Technical Document LA25043

Application under the *Agricultural Operation Practices Act* for a confined feeding operation, manure collection area, and/or manure storage facility(ies)

NRCB USE ONLY	Application number	Legal land description
<input type="checkbox"/> Approval <input type="checkbox"/> Registration <input checked="" type="checkbox"/> Authorization <input type="checkbox"/> Amendment	<u>LA25043</u>	<u>Sec. 28-20-17 W4M</u>

Sundial Feedlot Expansion
Lathom, AB

Borrow Pond

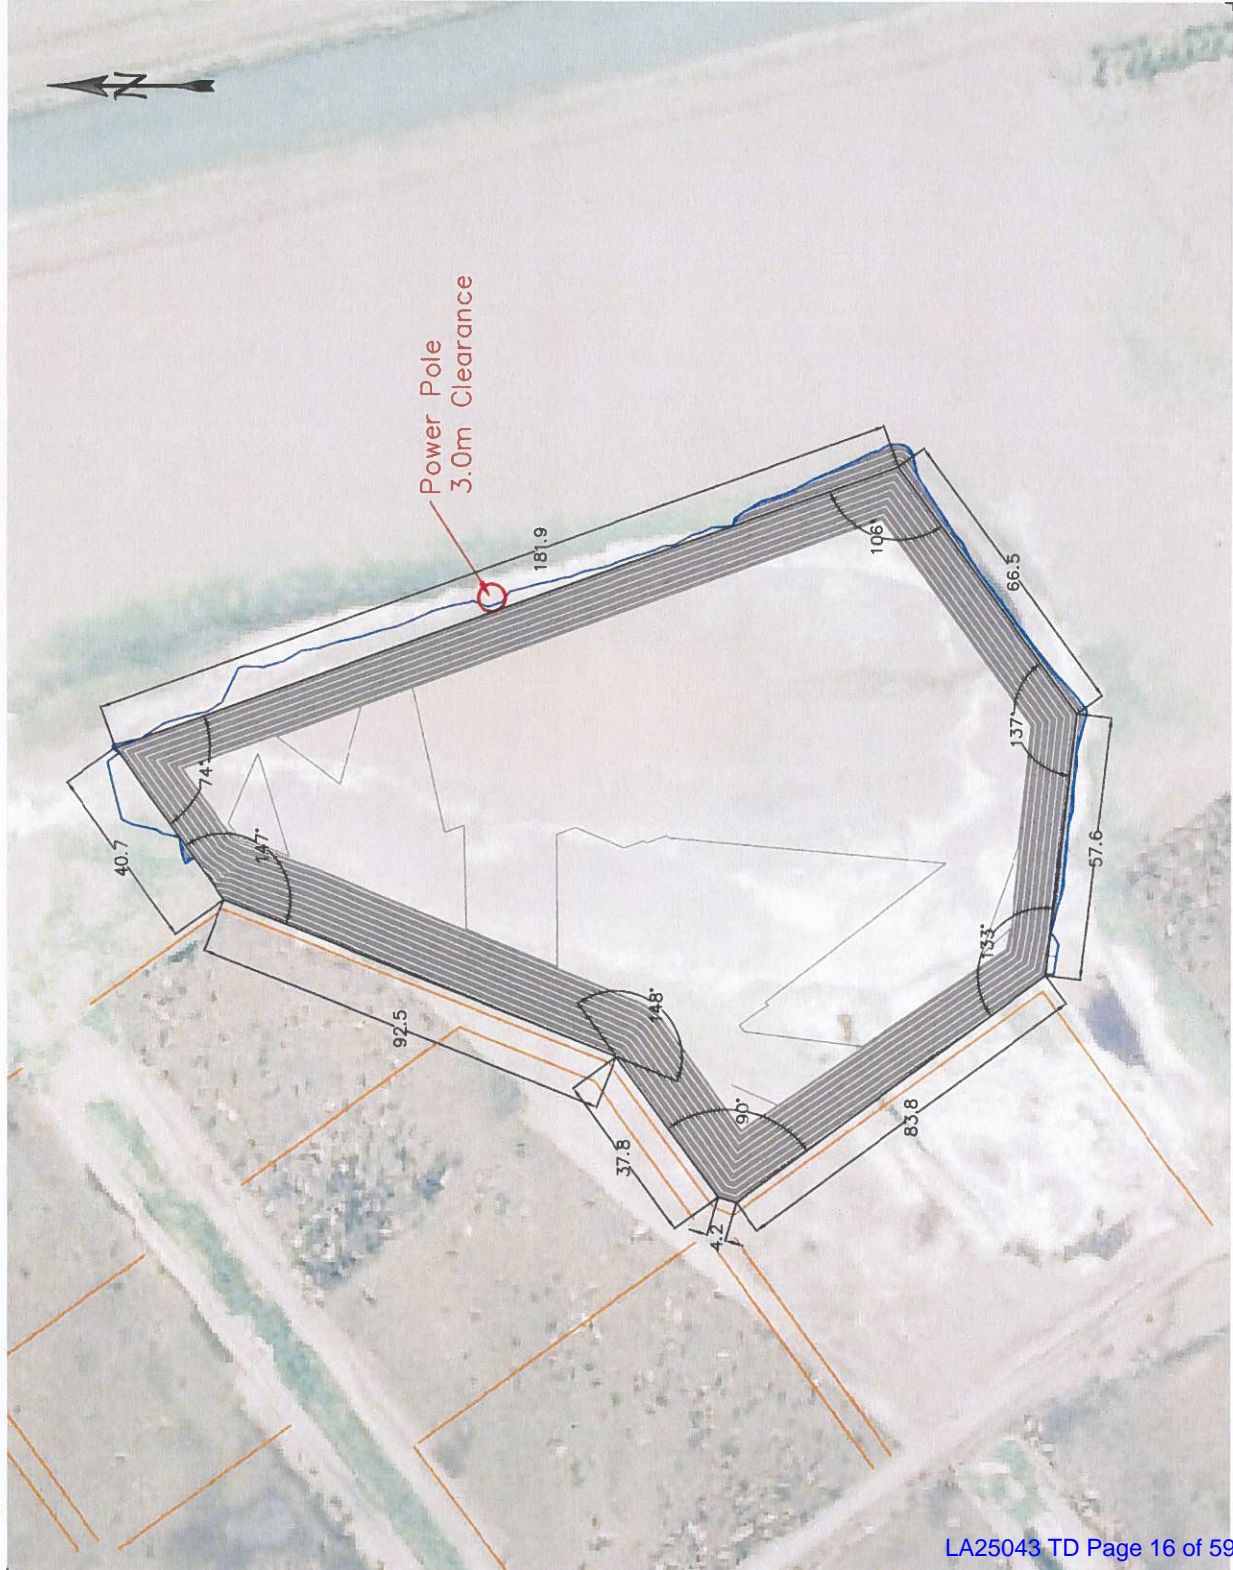
Catch basin calculator (calculation attached). Total volume @ freeboard: 37,376 m³

Runoff capacity requirements met: See calculation fo dimensions on page 16 below ☒ YES ☐ NO

The watertable was recorded to be at 0.5 m in the area of the inlet of the catch basin (borehole 1), but below 6 m (borehole 2) or below drilling depth everywhere else in CB area (boreholes 3-6). It is likely that the shallow water table in this area is caused by recent runoff from the runoff contributing feedlot pens.

The signing engineer proposed a thickness of 1.2 m for the compacted clay liner. The recommendation is based on an equivalency calculation comparing the compacted clay liner with the required hydraulic conductivity of a natural occurring protective layer. This calculation is not required. The requirement for a compacted clay liner for catch basins are 1 m of compacted clay with a hydraulic conductivity of 5×10^{-7} cm/sec. Therefore, a thickness of 1 m for the liner is sufficient.
